TREE SAVE AREA/
STOCKPILE SUBMITTAL

THE RAPIDS AT BELMEADE

OVERALL SITE PLAN
REVISED 07.19.2016 FOR UPDATED TREE
SAVE AND STOCKPILE AREAS

REVISION #2 to Ph. 1
and new Ph. 2

SITE PLAN 2

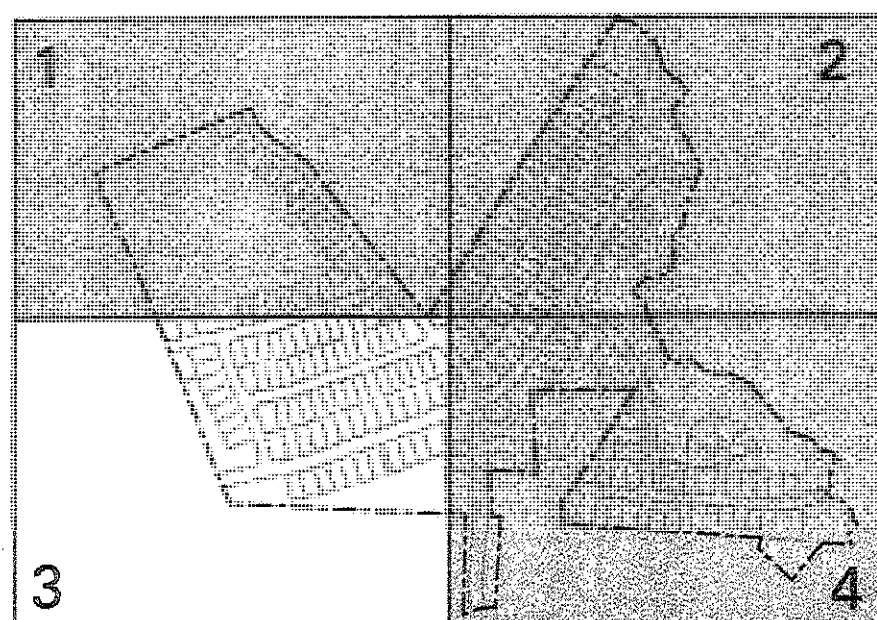
Add end of road treatment
and signage as specified in
CLDSM. Add this note to
dead end streets. Add
standard detail.

TASK: SITE PLAN 4

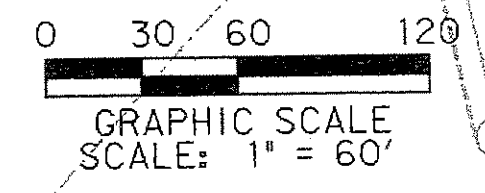
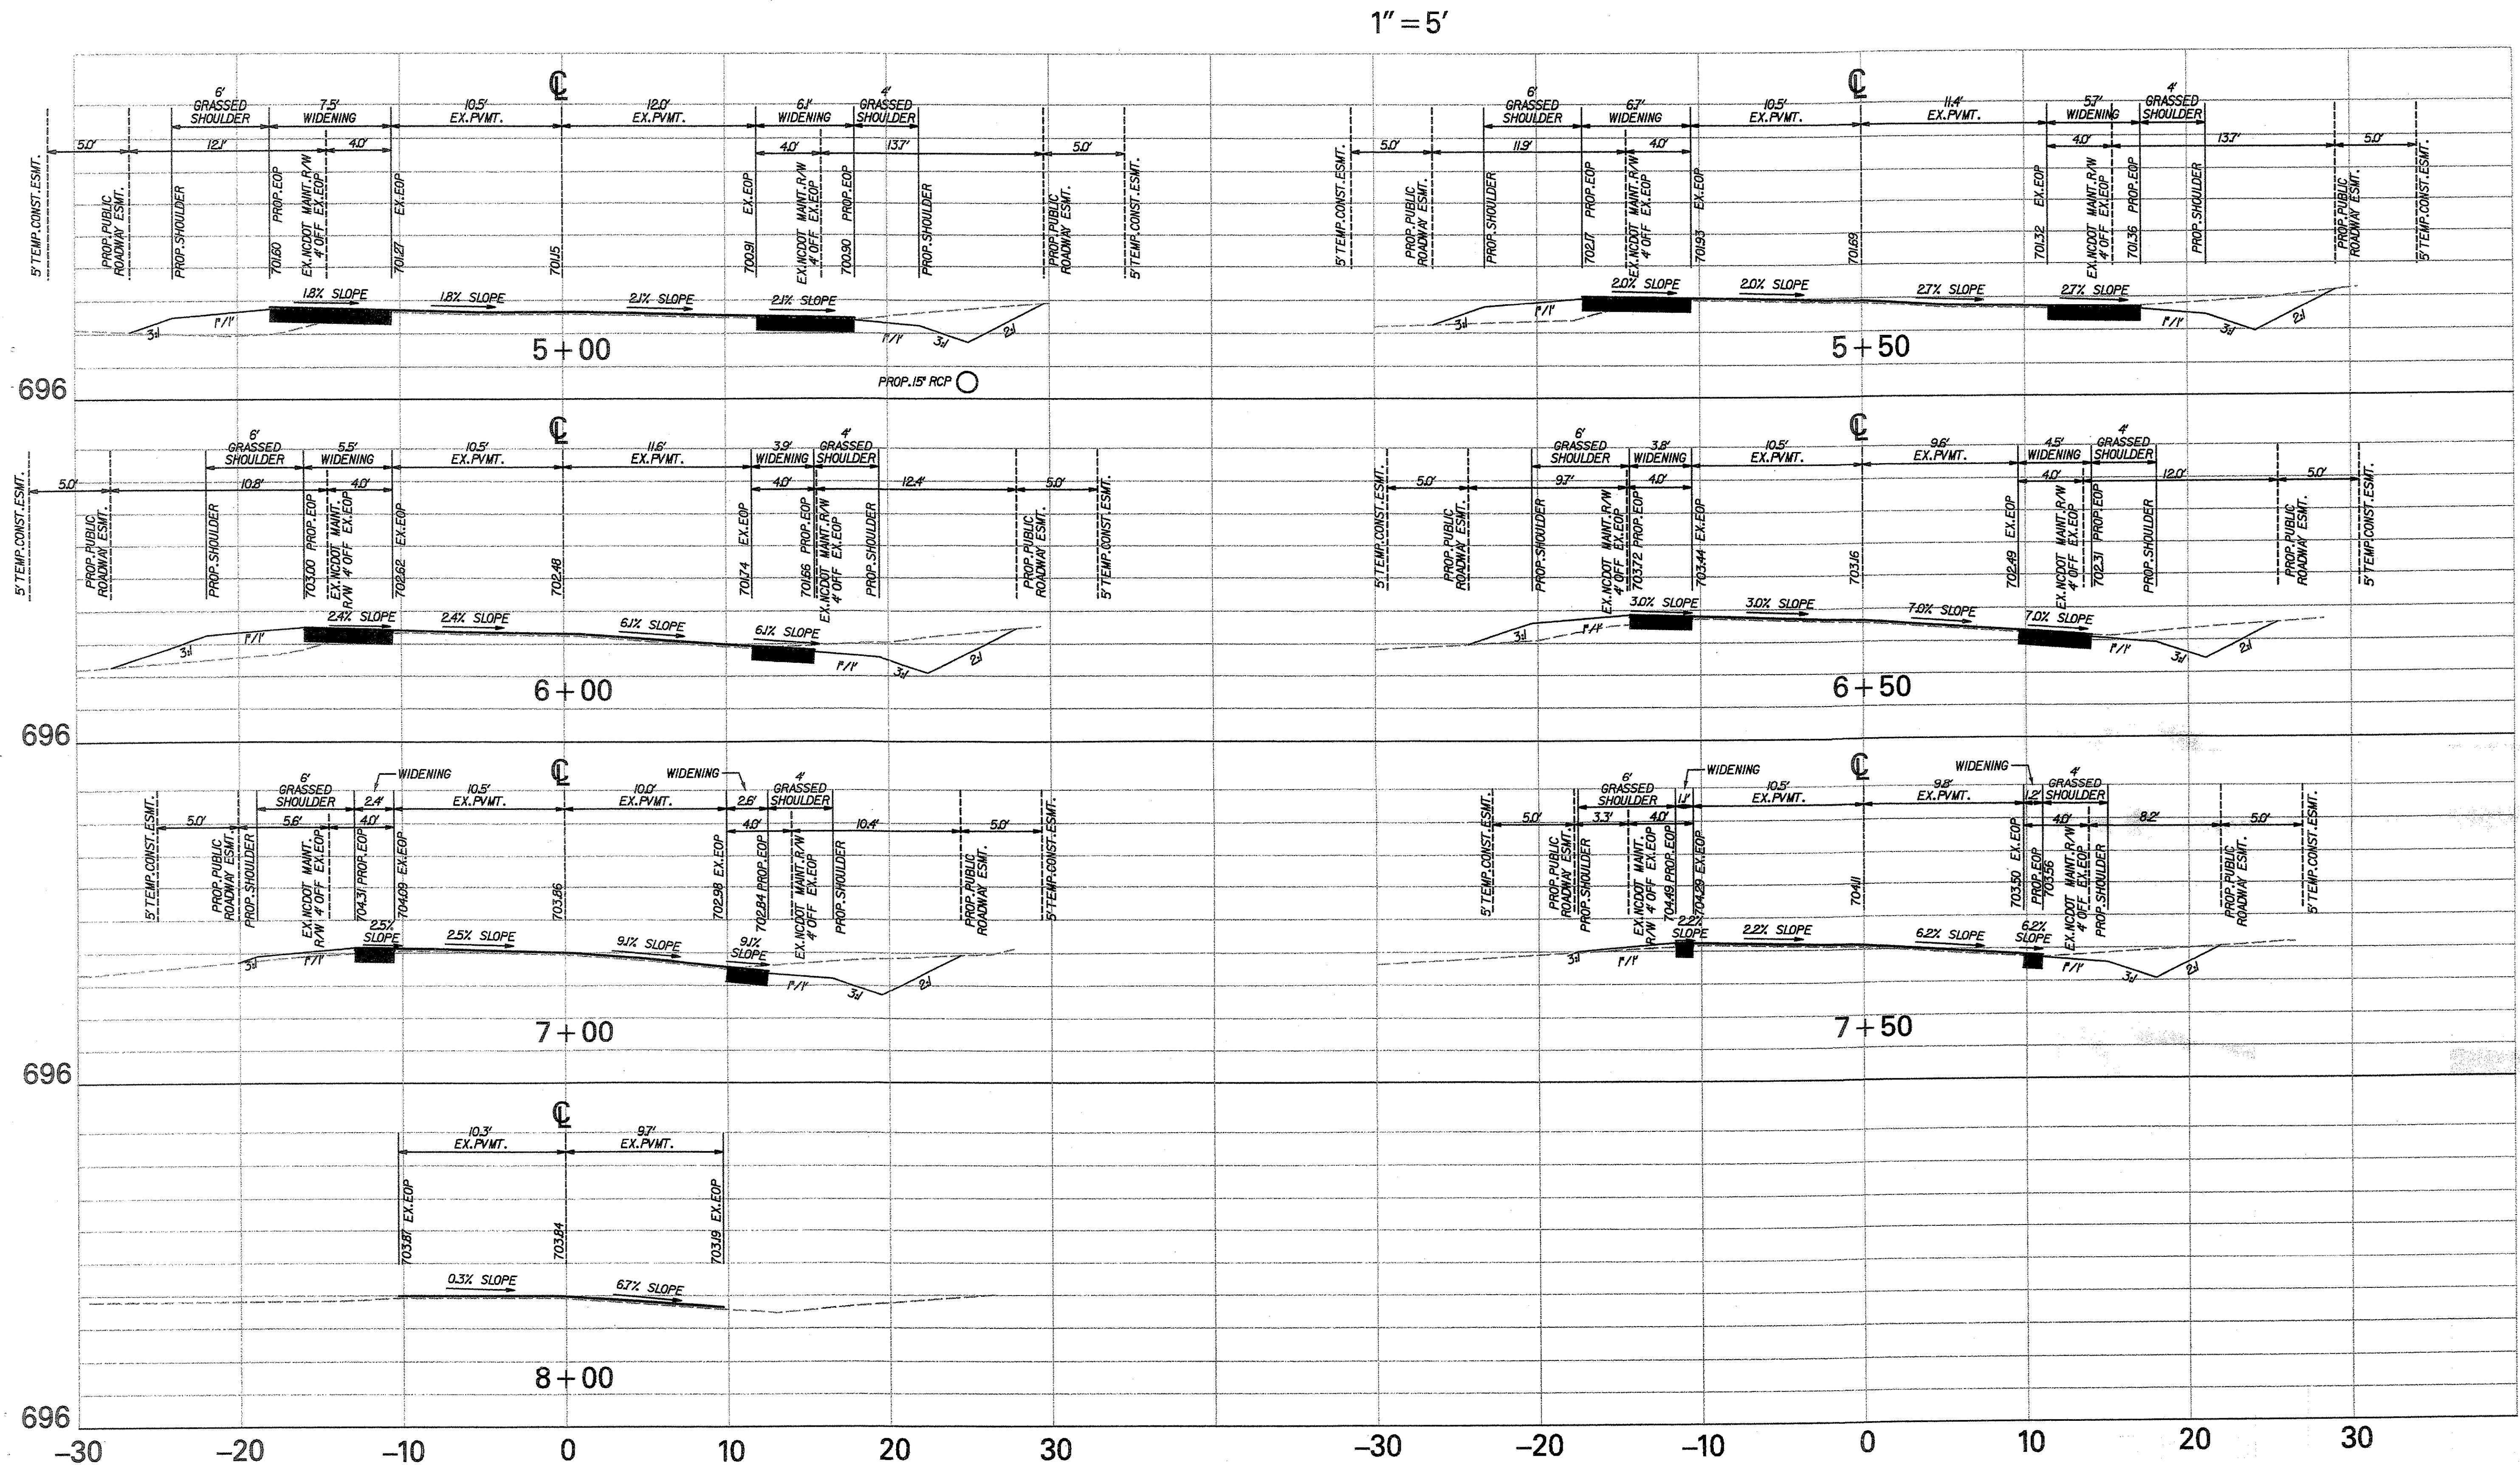
Do we need temporary turnaround treatment here?

Add end of road treatment and signage as specified in CLDSM. Add this note to dead end streets. Add standard detail.
